22 February 2021

Addition and Renovations to Richland Senior Center | City of Richland  
WBA Project No. 1219

## ADDENDUM NO. 02

A101  
FLOOR PLAN

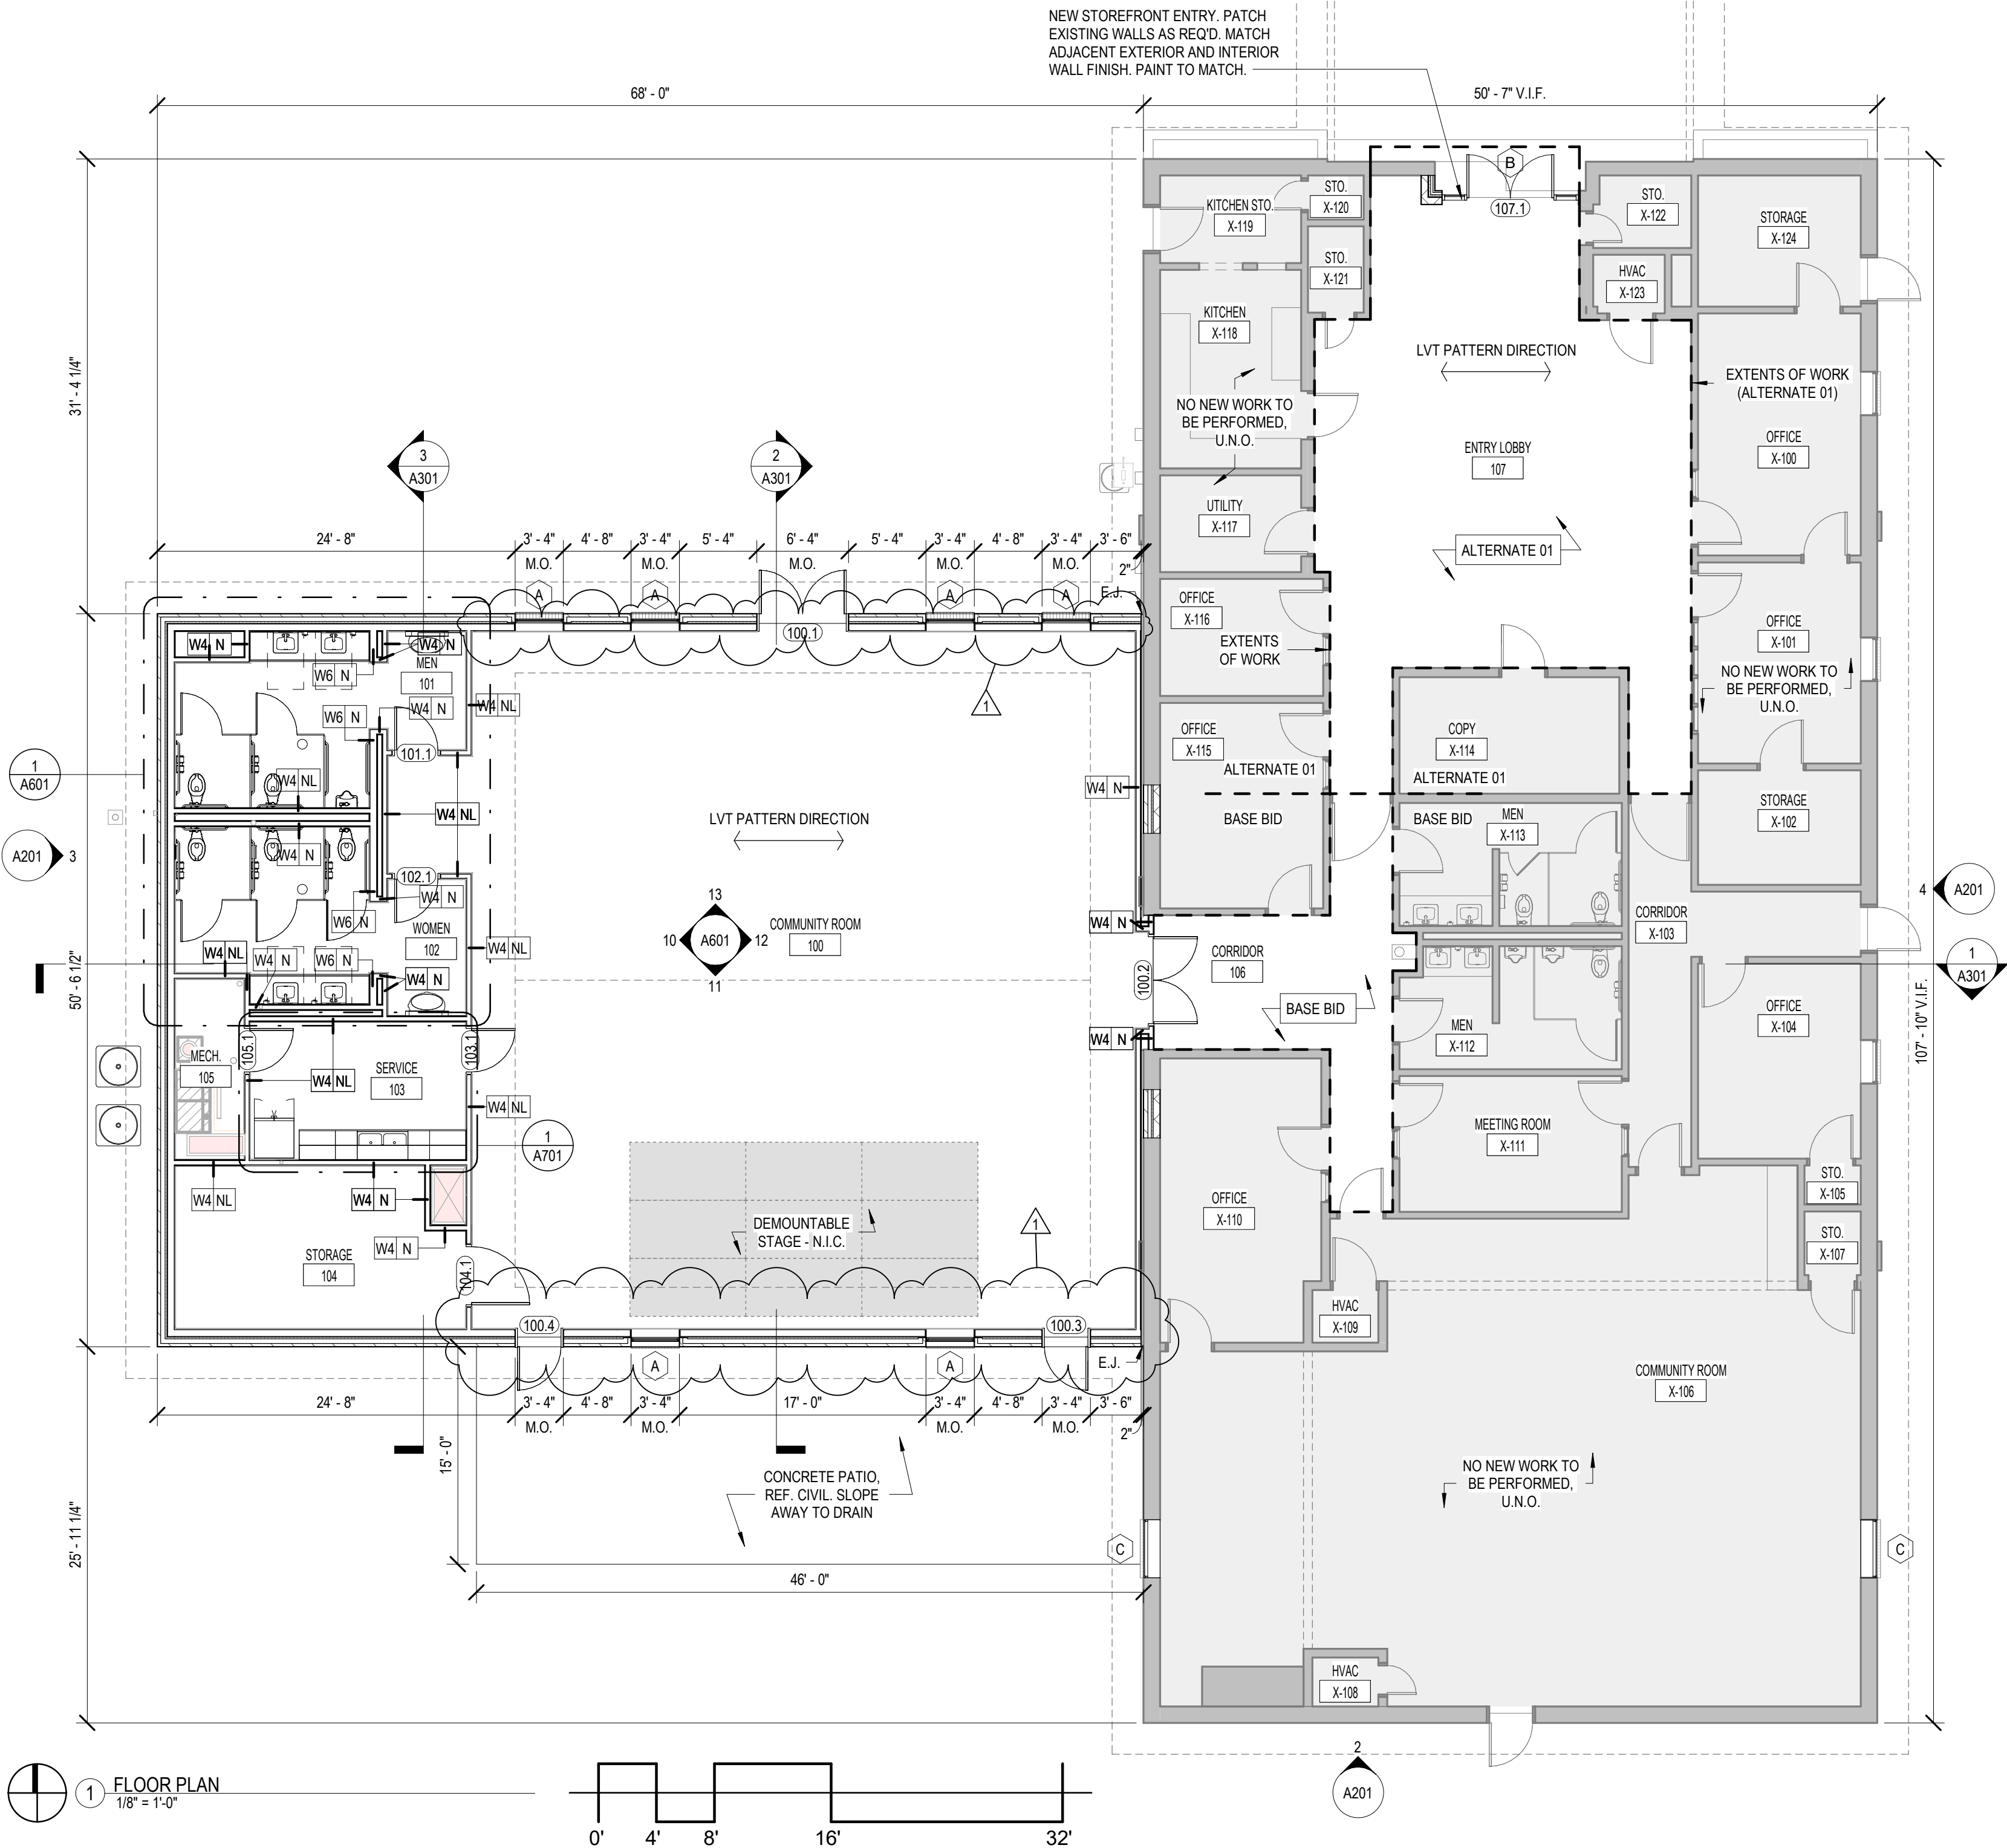
| <b>ITEM NO. 05</b> | <b>SHEET A101</b><br><b>ADD</b> enclosed sheet in its entirety to the drawing set. <b>REVISES</b> double exterior walls at <b>100 COMMUNITY ROOM.</b> |
